Project Name & Address
VOLKSWAGEN HATFIELD
COMET WAY, HATFIELD, AL10 9TF
Residential Development
Drawing Title
AMENDED FLOOR PLANS- THIRD FLOOR

Drawn By	F.P	Date	03.10.2022
Checked By	F.J	Date	13.10.2022
Approved By	B.R	Date	14.10.2022
Drawing Number	HAT-RDB-XX-03-DR-A-NMA-0203		
Sheet No.	01	Scale	1:100
Orig. Sheet Size	@A0	Rev.	R02

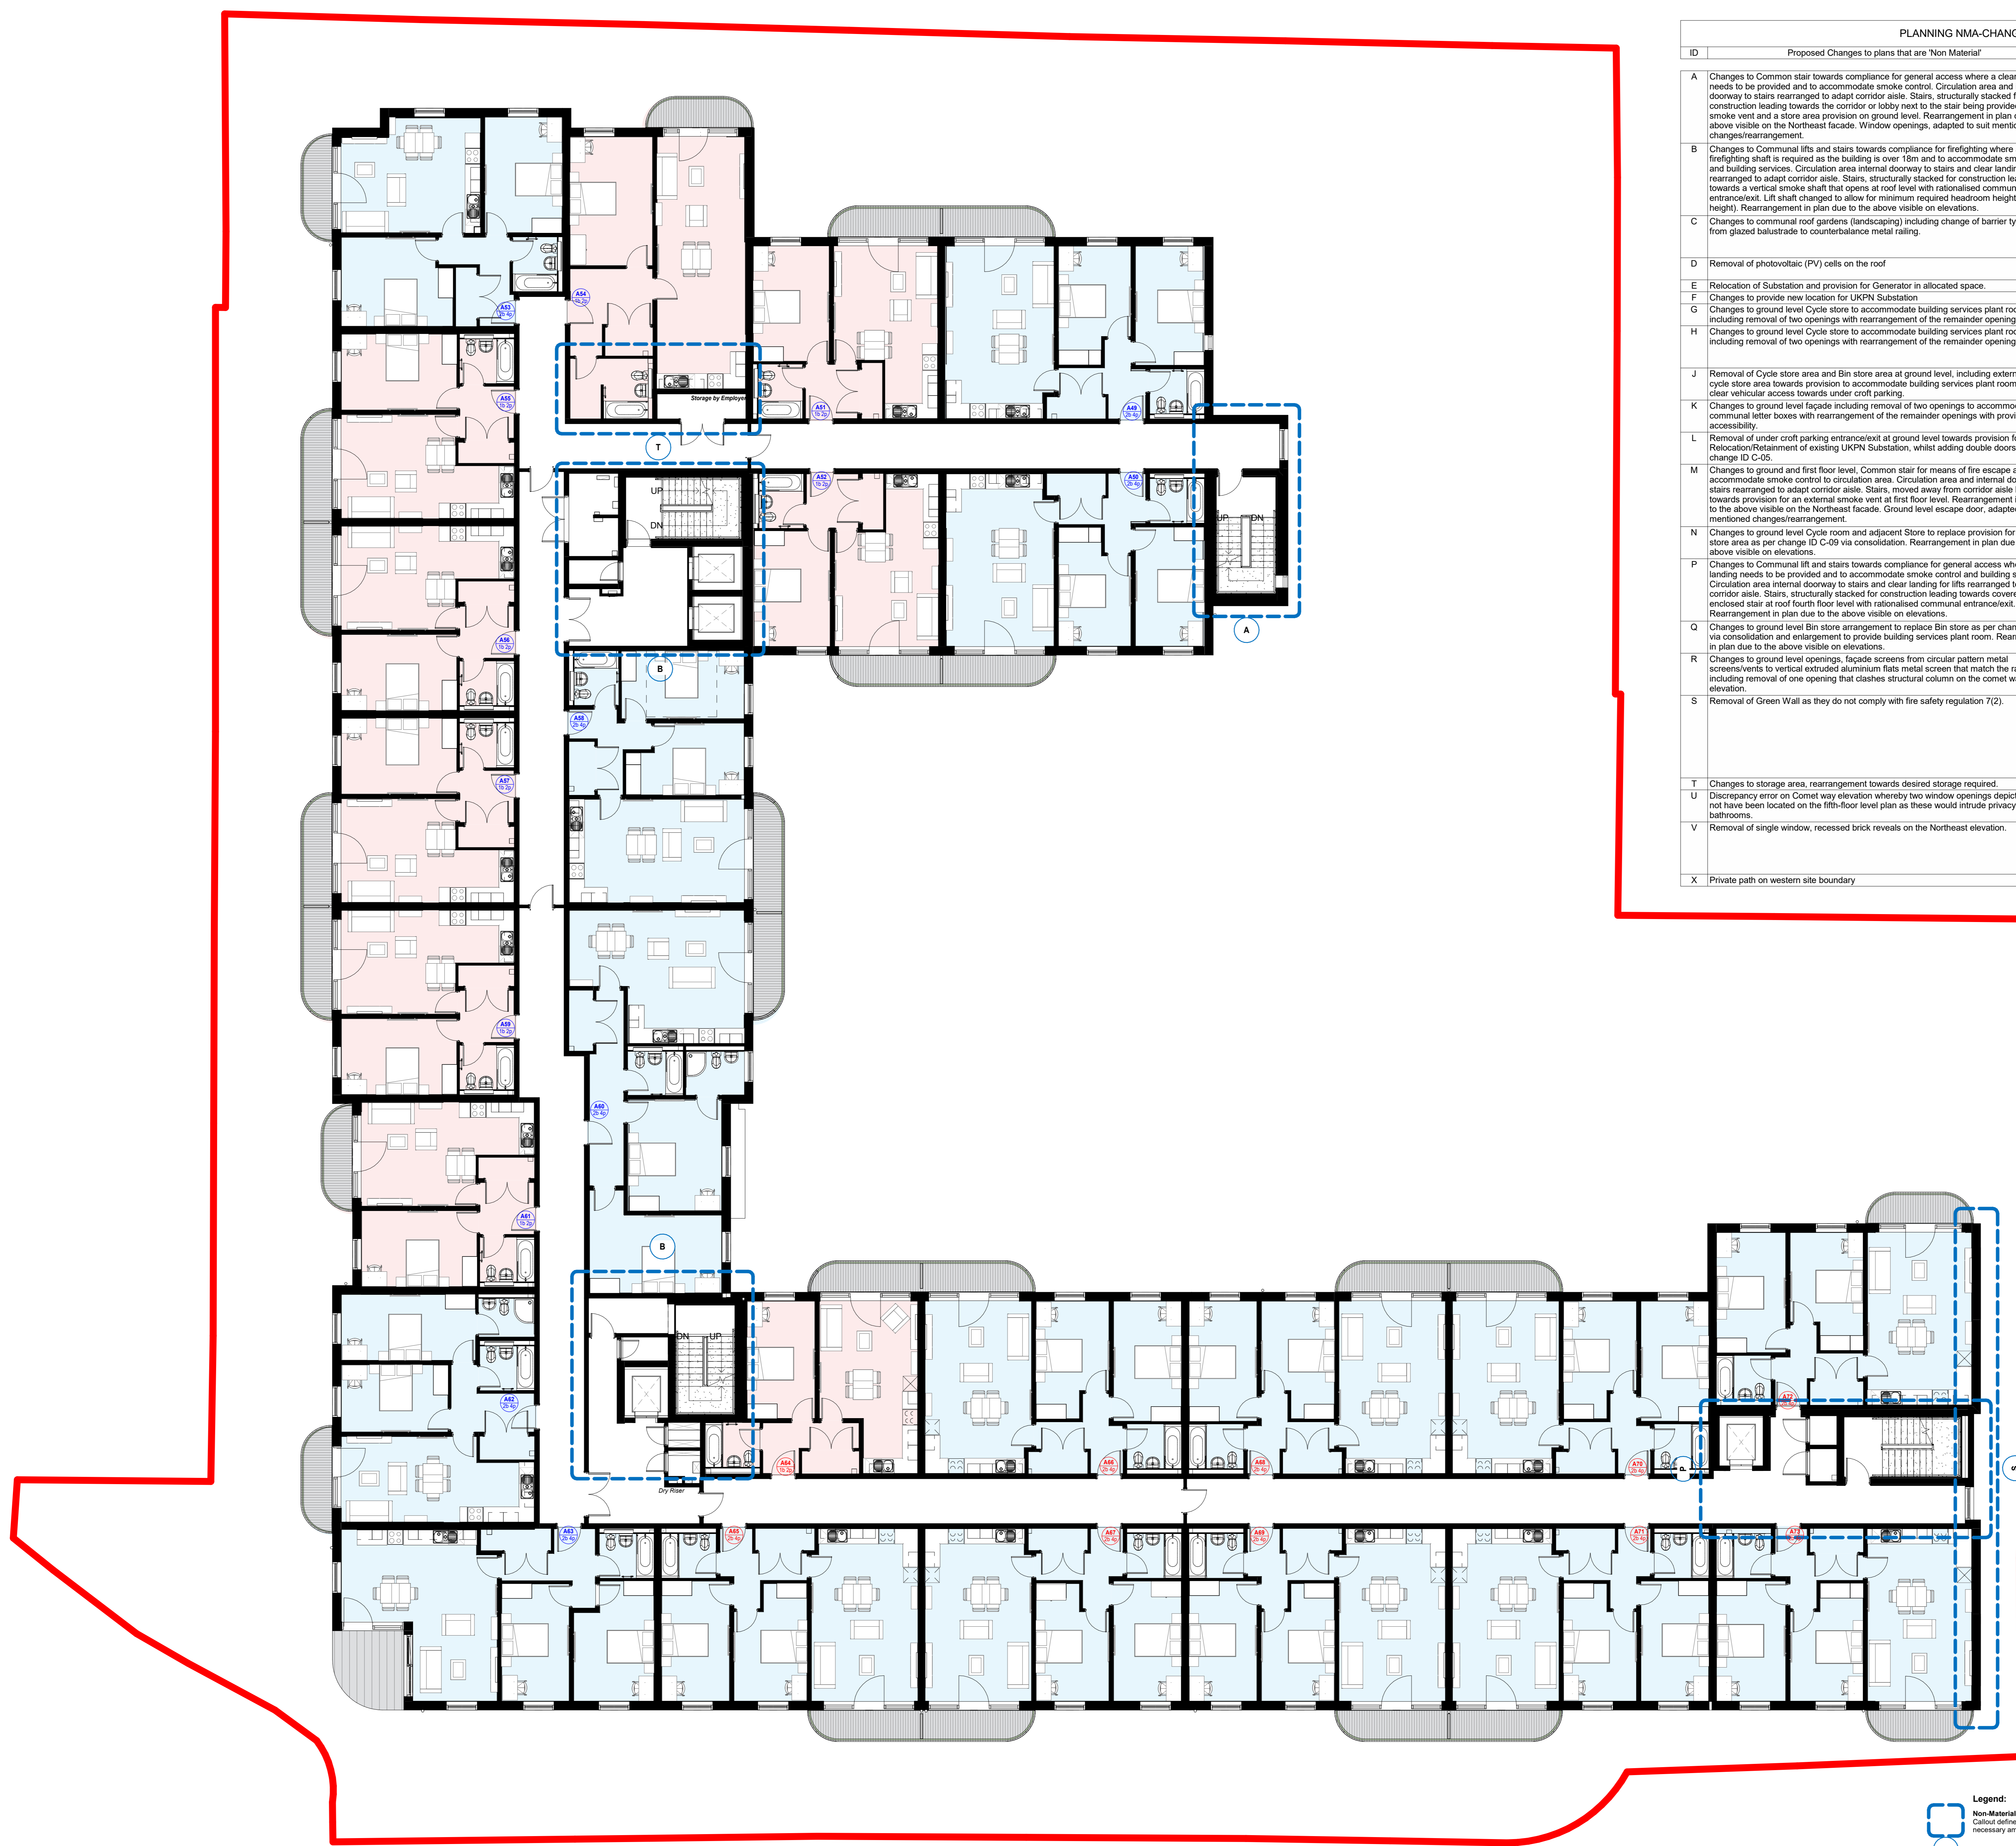
PLANNING NMA-CHANGE LIST		
ID	Proposed Changes to plans that are 'Non Material'	Reason for 'Amendment'
A	Changes to Common stair towards compliance for general access where a clear landing needs to be provided and to accommodate smoke control. Circulation area and internal doorway to stairs rearranged to adapt corridor aisle. Stairs, structurally stacked for construction leading towards the corridor or lobby next to the stair being provided with a smoke vent and a store area provision on ground level. Rearrangement in plan due to the above visible on the Northeast facade. Window openings, adapted to suit mentioned changes/rearrangement.	Compliance towards Building Regulations, Part-K-Protection from falling, collision and impact and Part-B-Fire safety
B	Changes to Communal lifts and stairs towards compliance for firefighting where a firefighting shaft is required as the building is over 18m and to accommodate smoke control and building services. Circulation area internal doorway to stairs and clear landing for lifts rearranged to adapt corridor aisle. Stairs, structurally stacked for construction leading towards a vertical smoke shaft that opens at roof level with rationalised communal entrance/exit. Lift shaft changed to allow for minimum required headroom height (Overhead height). Rearrangement in plan due to the above visible on elevations.	Compliance towards Building Regulations, Part-K-Protection from falling, collision and impact, Part-B-Fire safety, and Provision for minimum required headroom height as per standards EN81-20

C	Changes to communal roof gardens (landscaping) including change of barrier type (railing) from glazed balustrade to counterbalance metal railing.	To contribute positively towards biodiversity via balance of soft and hard landscaping schemes including provisions for bird and bat boxes, whilst maintaining overall uniformity for railing type.
D	Removal of photovoltaic (PV) cells on the roof	PV was not required as Part L requirement was met using Exhaust Air Heat Pumps.
E	Relocation of Substation and provision for Generator in allocated space.	Provision for separate secluded area for generator
F	Changes to provide new location for UKPN Substation	Provision for future relocation for UKPN Substation
G	Changes to ground level Cycle store to accommodate building services plant rooms including removal of two openings with rearrangement of the remainder openings.	Provision towards Building Services, Secondary LV switch room and Comms room.

H	Changes to ground level Cycle store to accommodate building services plant rooms including removal of two openings with rearrangement of the remainder openings.	Provision towards secure access and splitting into 4 small bin stores to comply with recent updates of having maximum 8 large (1100lrs) receptacles within.
J	Removal of Cycle store area and Bin store area at ground level, including external door in cycle store area towards provision to accommodate building services plant room including clear vehicular access towards undercroft parking.	Provision towards Building Services, Primary LV switch room and vehicular access towards undercroft parking.
K	Changes to ground level facade including removal of two openings to accommodate communal letter boxes with rearrangement of the remainder openings with provision for accessibility.	Provision towards communal letter boxes
L	Removal of undercroft parking entrance/exit at ground level towards provision for Relocation/Retention of existing UKPN Substation, whilst adding double doors as per change ID C-05.	Provision towards single point of entry/exit for undercroft parking and towards relocation/retention of existing UKPN Substation mentioned in change ID-E.

M	Changes to ground and first floor level, Common stair for means of fire escape and to accommodate smoke control to circulation area. Circulation area and internal doorway to stairs rearranged to adapt corridor aisle. Stairs, moved away from corridor aisle leading towards provision for an external smoke vent at first floor level. Rearrangement in plan due to the above visible on the Northeast facade. Ground level escape door, adapted to suit mentioned changes/rearrangement.	Compliance towards Building Regulations, Part-B-Fire safety.
N	Changes to ground level Cycle room and adjacent Store to replace provision for Cycle store area as per change ID C-09 via consolidation. Rearrangement in plan due to the above visible on elevations.	Provision towards replacement of removed cycle store mentioned in change ID-J.
P	Changes to Communal lift and stairs towards compliance for general access where a clear landing needs to be provided and to accommodate smoke control and building services. Circulation area internal doorway to stairs and clear landing for lifts rearranged to adapt corridor aisle. Stairs, structurally stacked for construction leading towards covered and enclosed stair at roof fourth floor level with rationalised communal entrance/exit. Rearrangement in plan due to the above visible on elevations.	Compliance towards Building Regulations, Part-K-Protection from falling, collision and impact, Part-B-Fire safety and Provision for stair enclosed/walkway that is directly covered.

Q	Changes to ground level Bin store arrangement to replace Bin store as per change ID C-09 via consolidation and enlargement to provide building services plant room. Rearrangement in plan due to the above visible on elevations.	Provision towards replacement of removed Bin store mentioned in change ID-J and provision for BCW Tank room
R	Changes to ground level openings, facade screens from circular pattern metal screens/vents to vertical extruded aluminium flats metal screen that match the railing type, including removal of one opening that clashes structural column on the corner way elevation.	To maintaining overall architectural uniformity and structural framing.
S	Removal of Green Wall as they do not comply with fire safety regulation 7(2).	Regulation 7(2), requires all residential blocks with top-storey heights over 18m to have all materials which become part of an external wall or specified attachment (e.g., balconies) to achieve class A2-s1, d0 or class A1, except for materials which are exempt as per regulation 7(3). Additionally, membranes used as part of external wall construction above ground should achieve a minimum of class B-s3, d0.

T	Changes to storage area, rearrangement towards desired storage required.	Provision towards desired storage required.
U	Discrepancy error on Comet way elevation whereby two window openings depicted would not have been located on the fifth-floor level plan as these would intrude privacy for the bathrooms.	Discrepancy error
V	Removal of single window, recessed brick reveals on the Northeast elevation.	The recessed brick reveals is towards the left of a single pane window for levels 1-4, whilst it changes to a double pane for level 5. To maintain architectural uniformity, we have detailed a constant double pane window for all levels.
X	Private path on western site boundary	For Façade maintenance MEWP access.
